# Groundwater Transfer Review Summary Form

Transfer/PA # T- 13531

Application: T-13531

Applicant Name: Glenn Chowning / Port of Morrow

Figure 1. Well Location Map

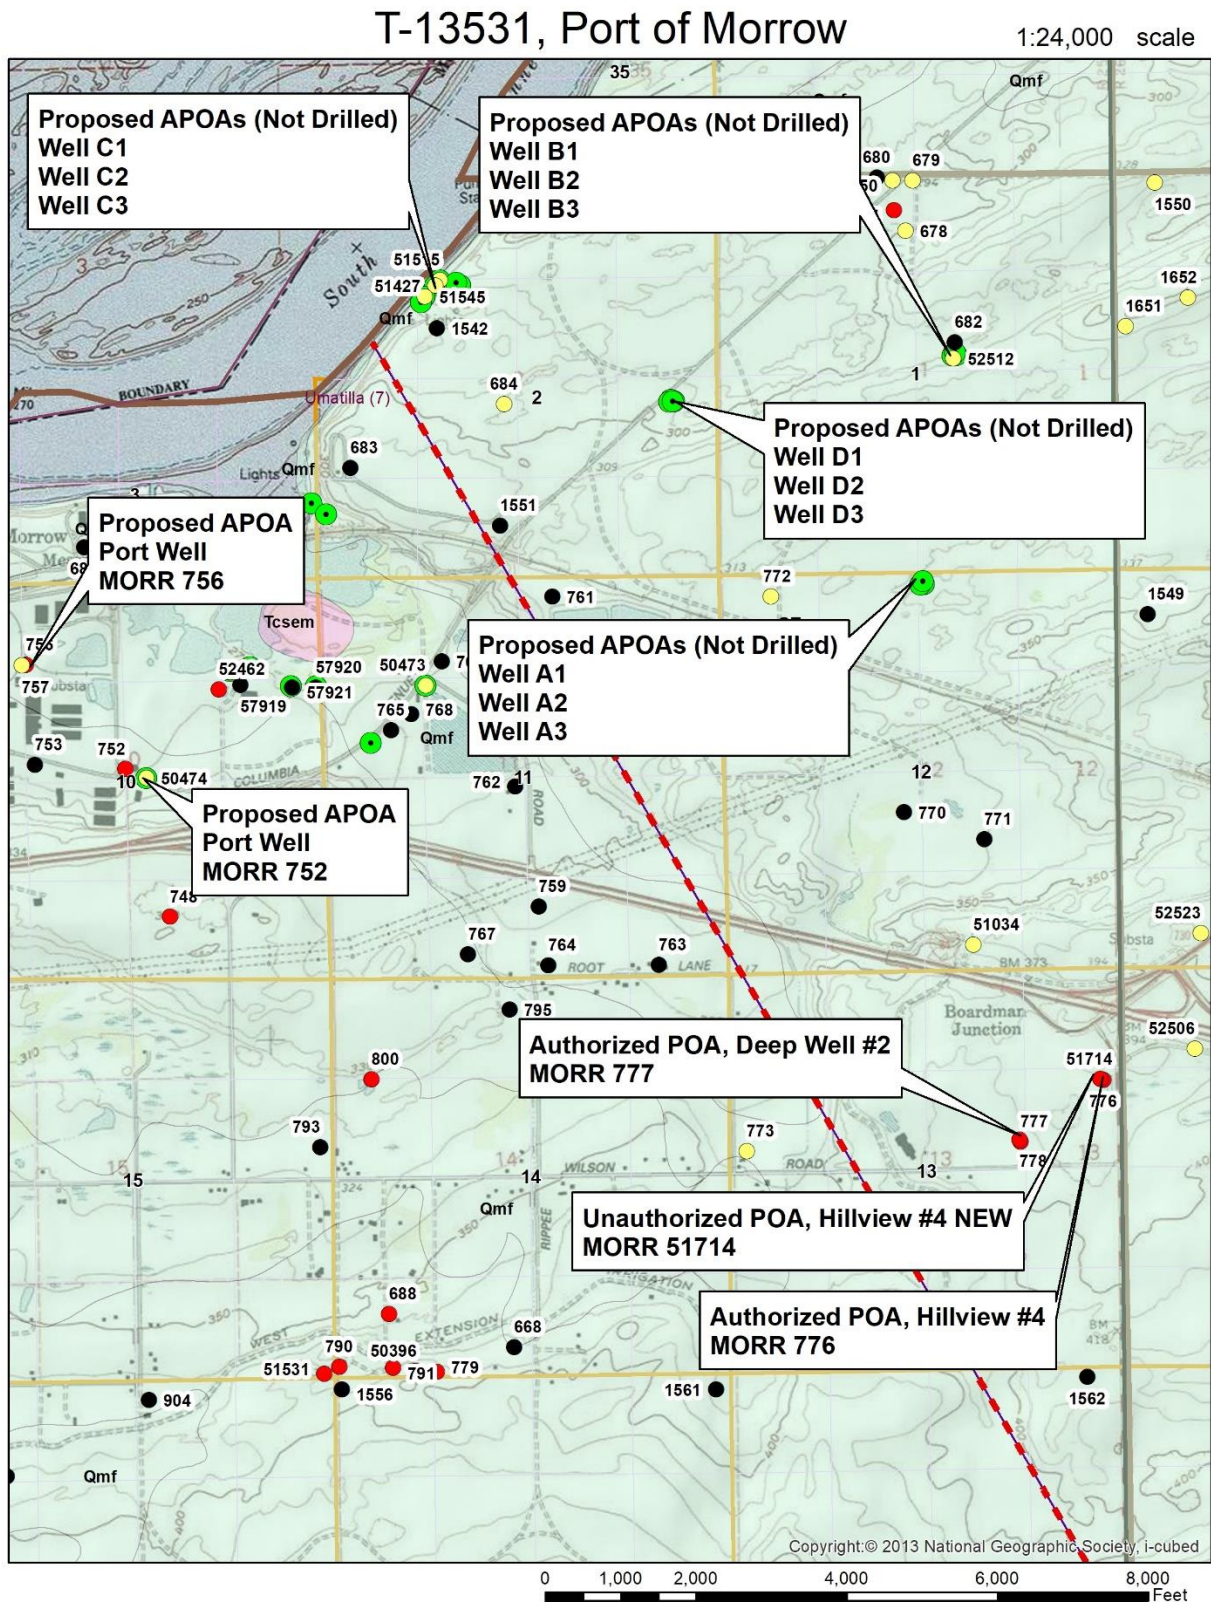
1. Basic description of the changes proposed in this transfer: This application proposes several changes to water right certificate 93290. The proposed changes are 1) change character of use from irrigation to municipal, 2) change place of use, and 3) add up to 14 additional POAs. Certificate 93290 currently authorizes MORR 776 and MORR 777 for irrigation use. T-13531 proposes to add two existing Port of Morrow wells 1/MORR 756 and 2/MORR 752 and up to 12 proposed wells for municipal use (see Figure 1 for well locations).

Figure 2. Geologic Cross-Section. Provided by Applicant's Agent.

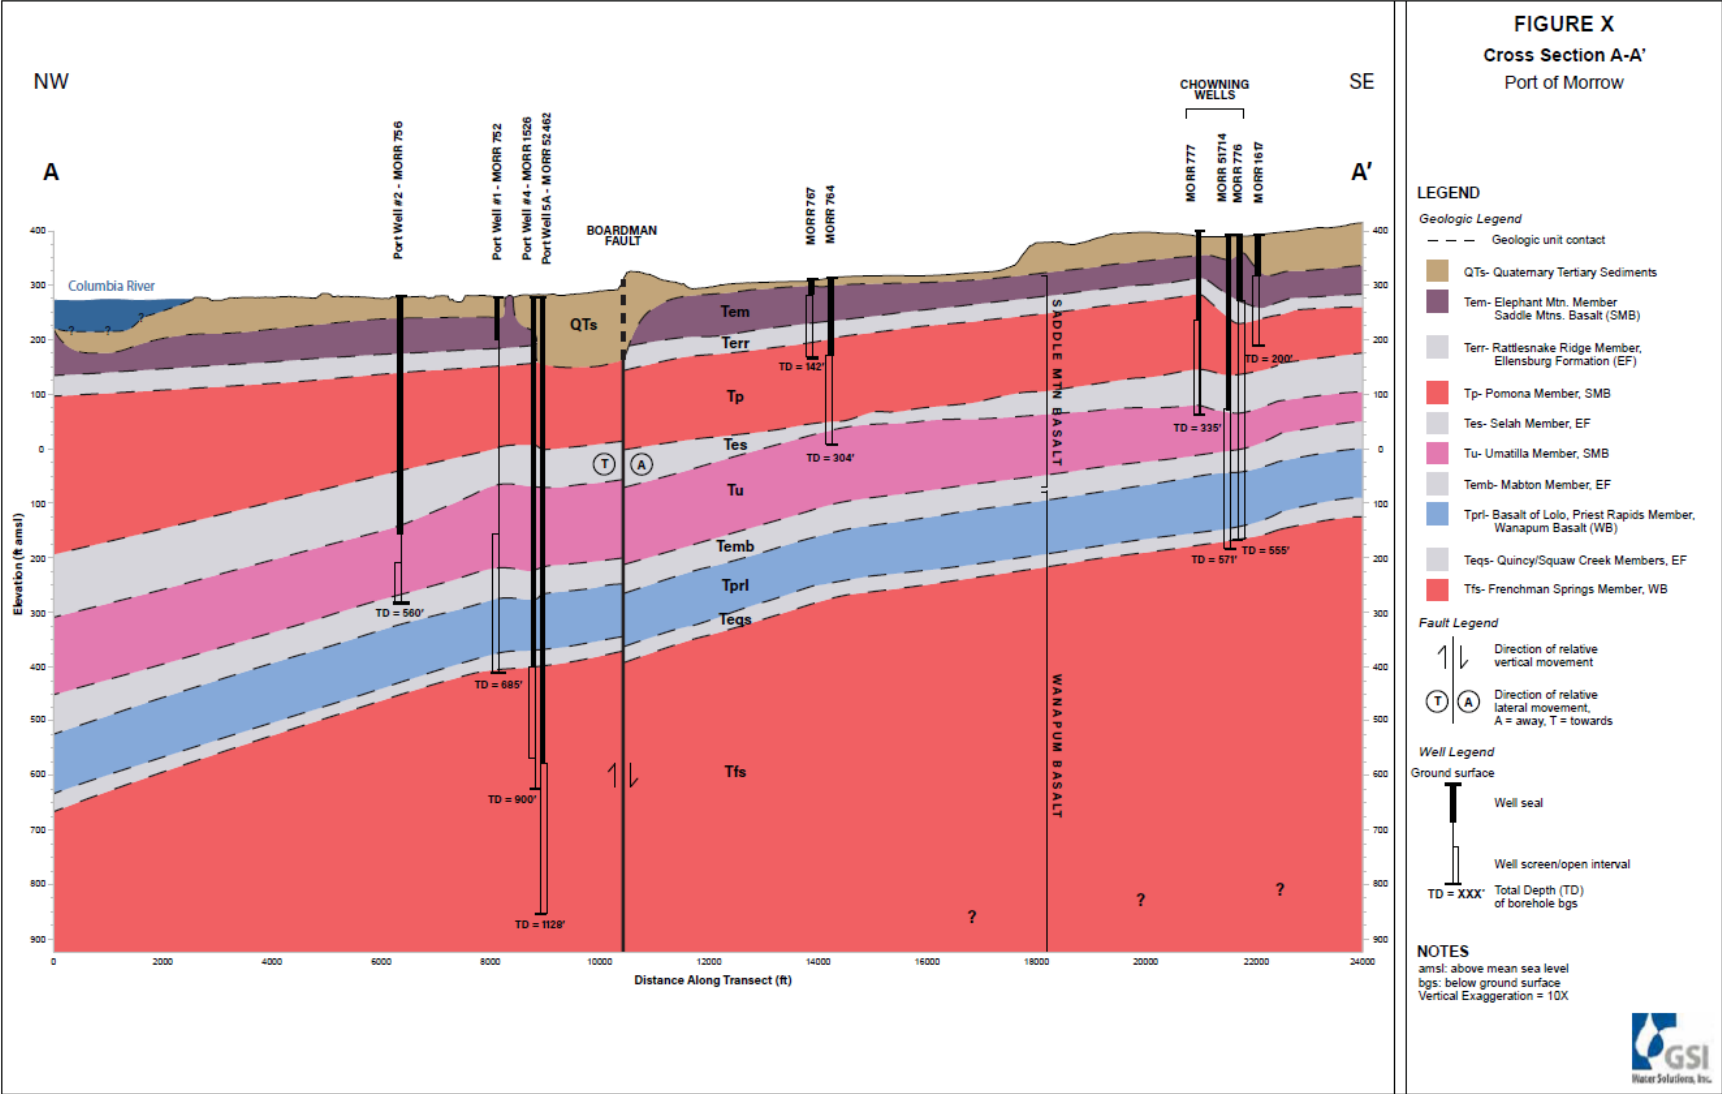
**NO (Applies to proposed POAs MORR 752 and MORR 756):** Available evidence indicates proposed POAs MORR 756 and MORR 752 do not develop the same source as the authorized POAs. A stratigraphic cross-section provided by the applicant's agent shows that the proposed POAs (MORR 756 and MORR 752) are open to many of the same stratigraphic units as the authorized POAs (MORR 777 and MORR 776) and the unauthorized POA (MORR 51714) (see figure 2). Although the wells are open to the same stratigraphic units, water level elevations in the proposed POAs are significantly lower than the authorized wells (Figure 3). The proposed POAs are located 2.5 miles northwest of the authorized POAs. Despite their proximity, the water level elevation and trends from the proposed POAs, MORR 756 and MORR 752, are approximately 100 feet lower than the authorized POAs. The proposed POAs are also on the opposite side of the Boardman fault, a large right-lateral strike-slip fault. Stratigraphic offset across the fault may impede groundwater flow and contribute to water level head differences.
